Project Name: Mt. Hope School – New BuildProject No.: 221125-140Architect: C2AEDate: 7/31/2023Bid Package No.: 2Bid Due Date: 08/03/2023

Addendum 3

Project No.:	22-0116	Date:	July 28, 2023
Project:	Mt. Hope Lansing School District SB-1785 Ingham County, MI	A/E Firm:	C2AE
Owner:	Lansing School District 519 West Kalamazoo Street Lansing, MI 48933	Project Manager:	Steve Jurczuk

INTERACTIVE FLAT PANEL DISPLAY ROUGH-IN

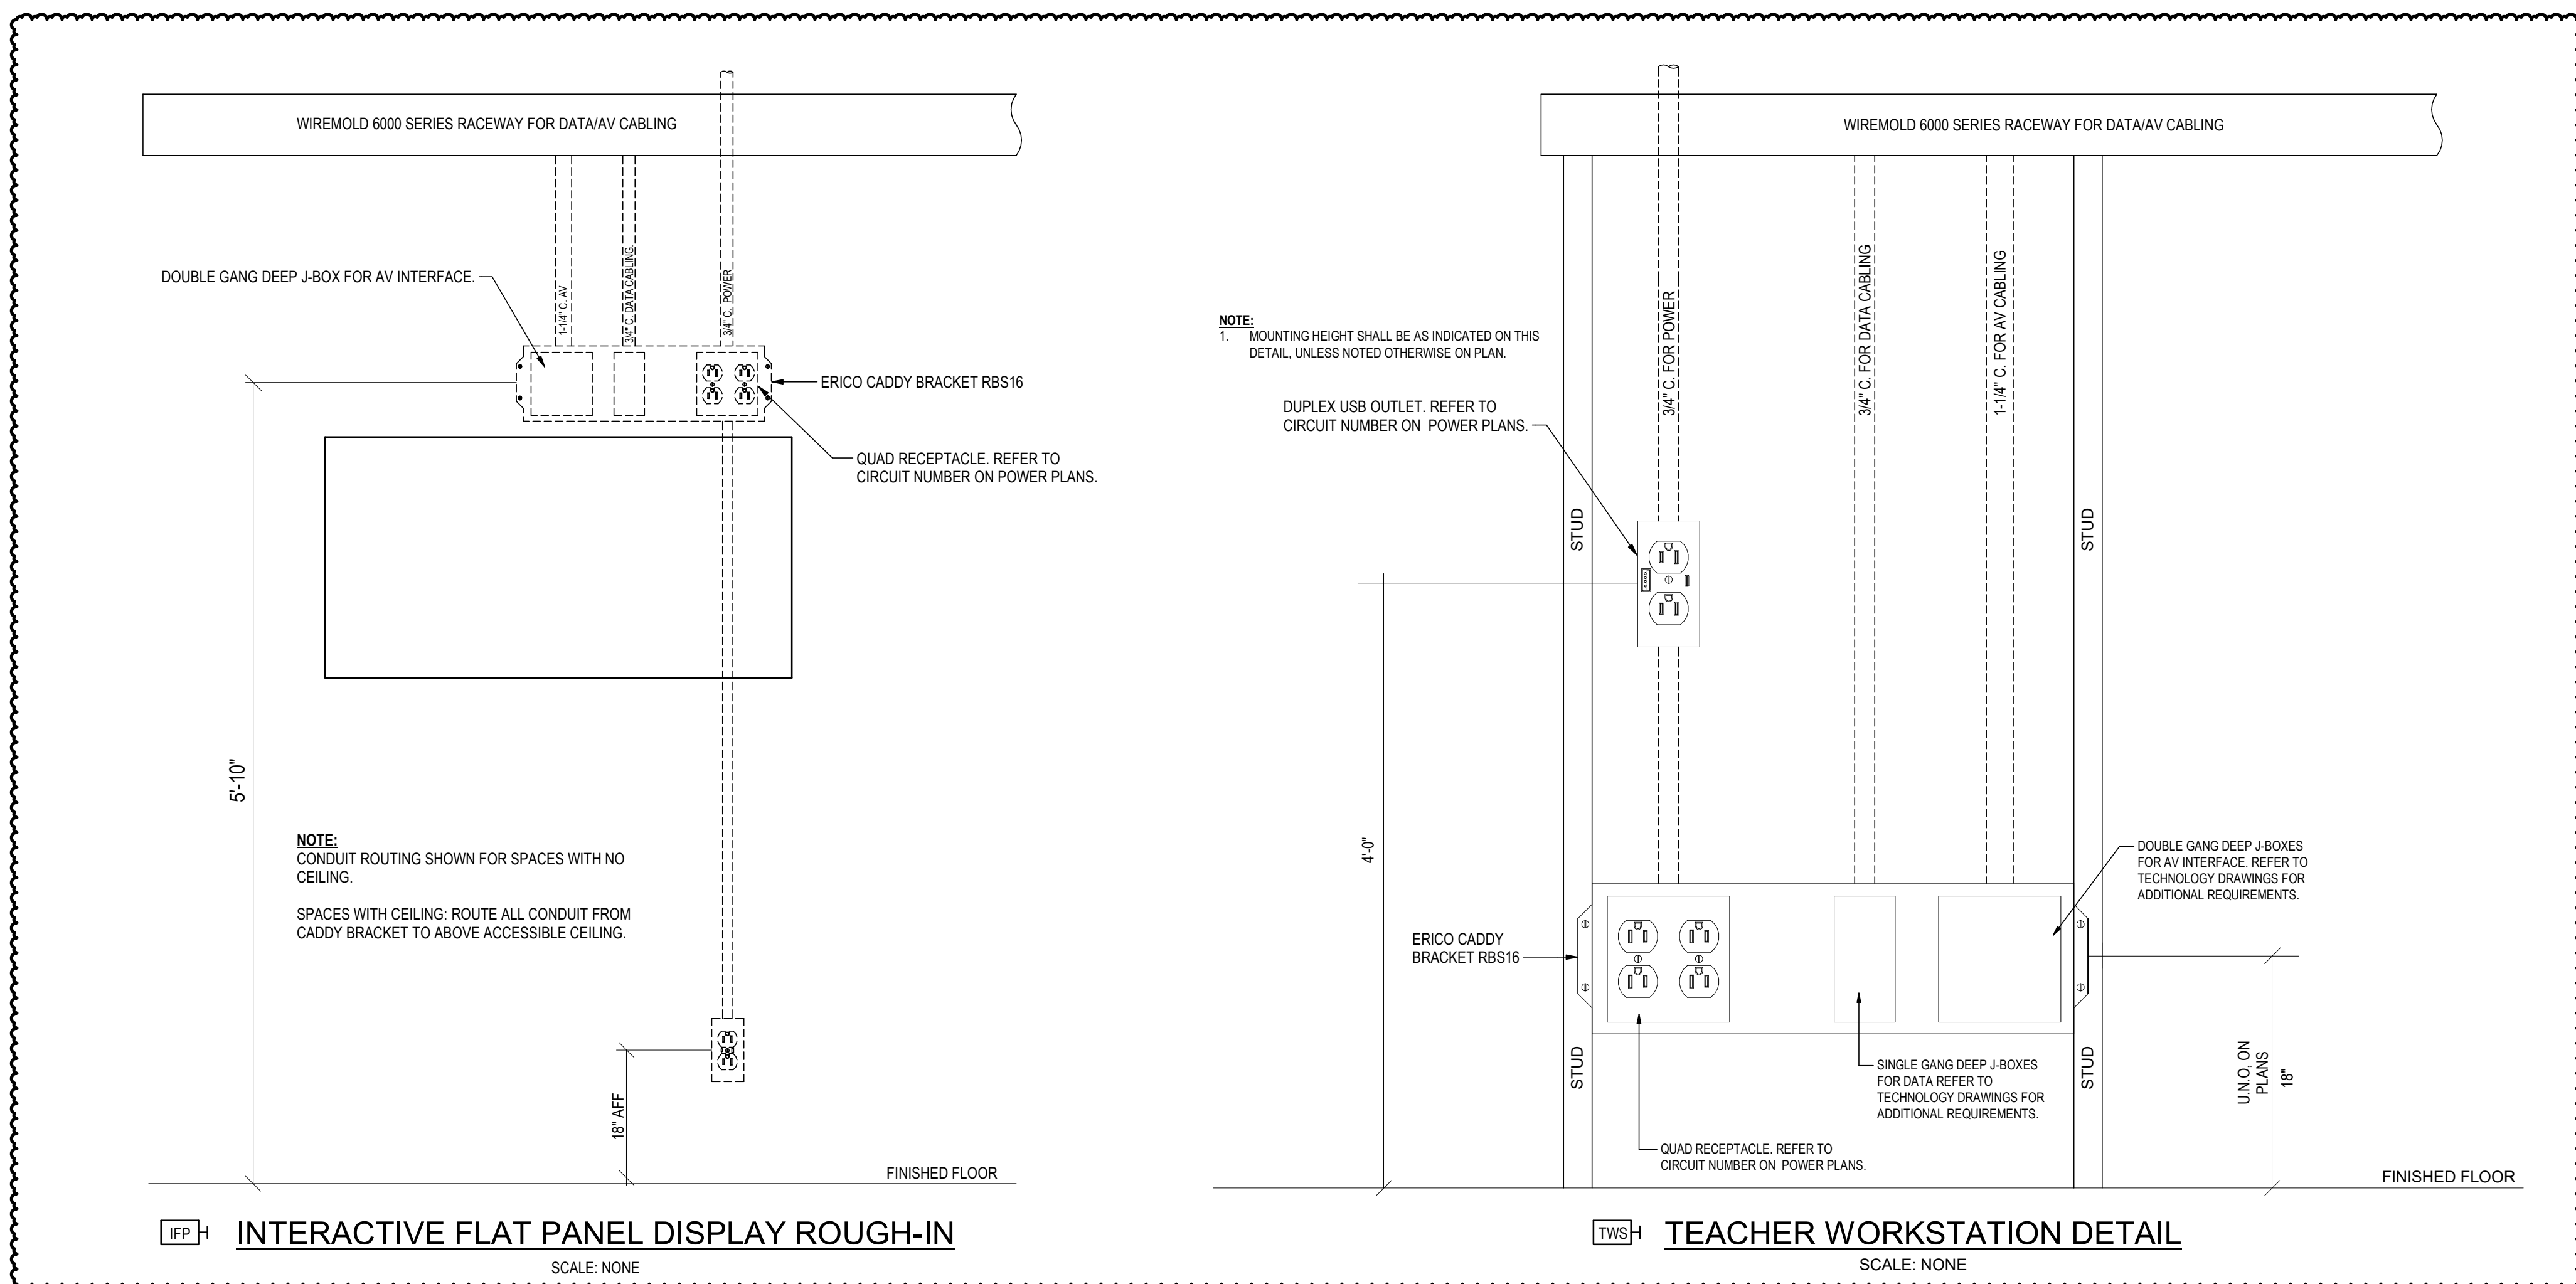
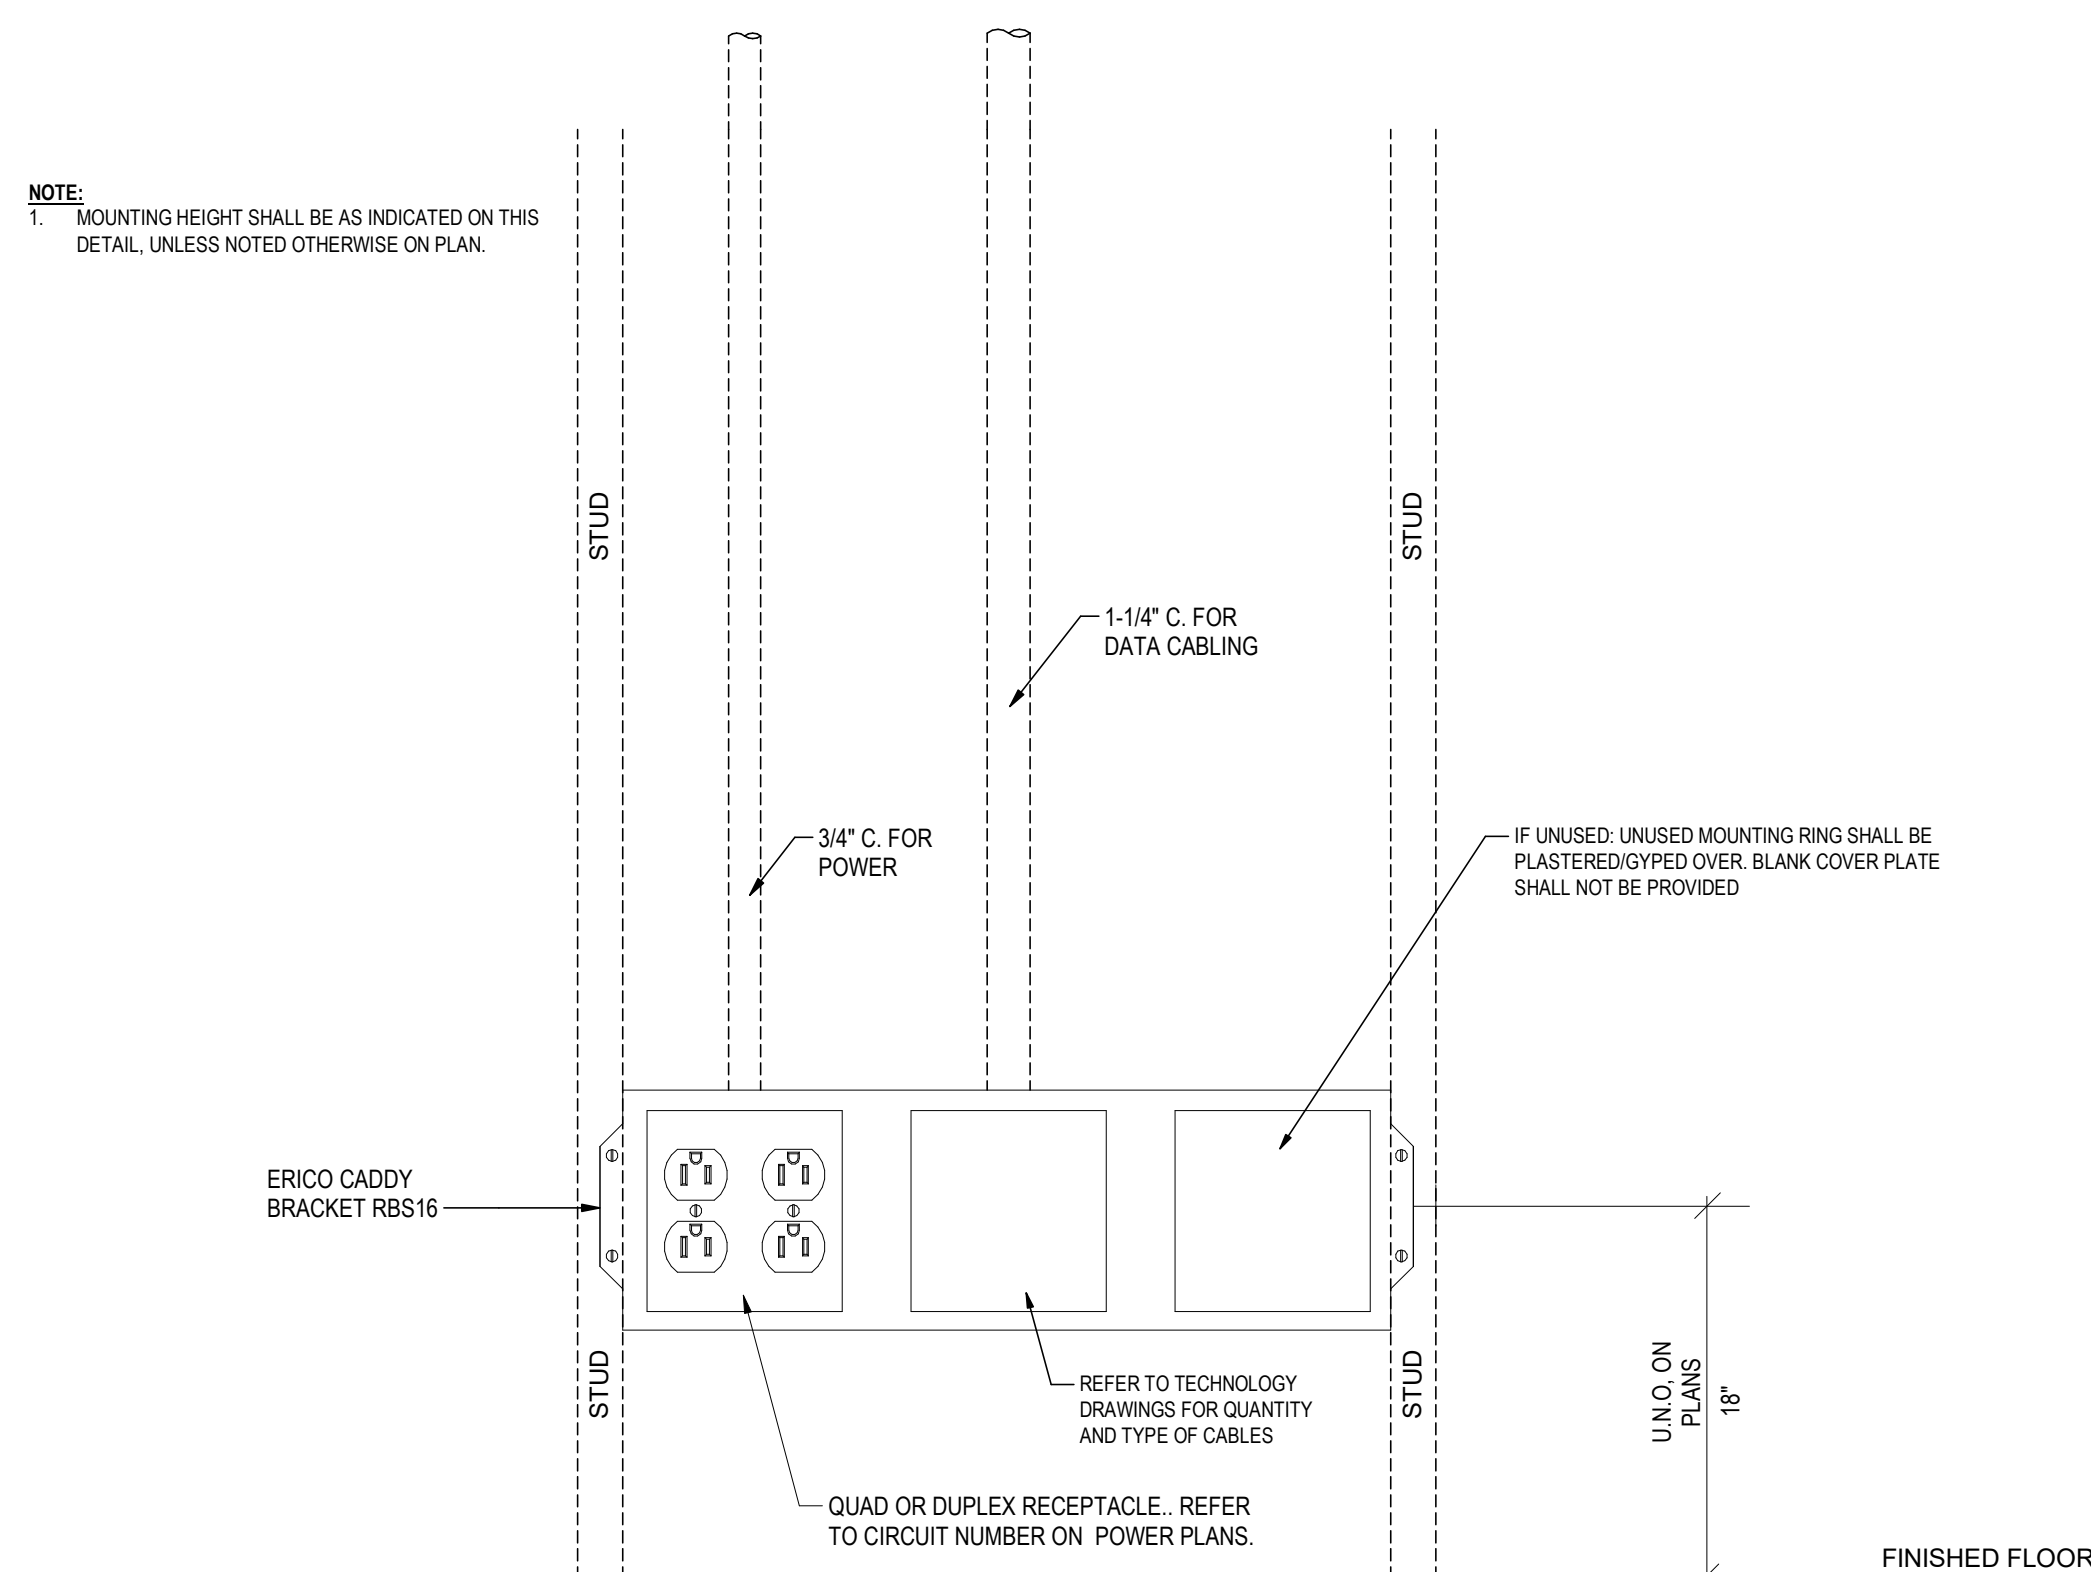
Revise Interactive Flat Panel and Teacher Workstation details to align with Technology.
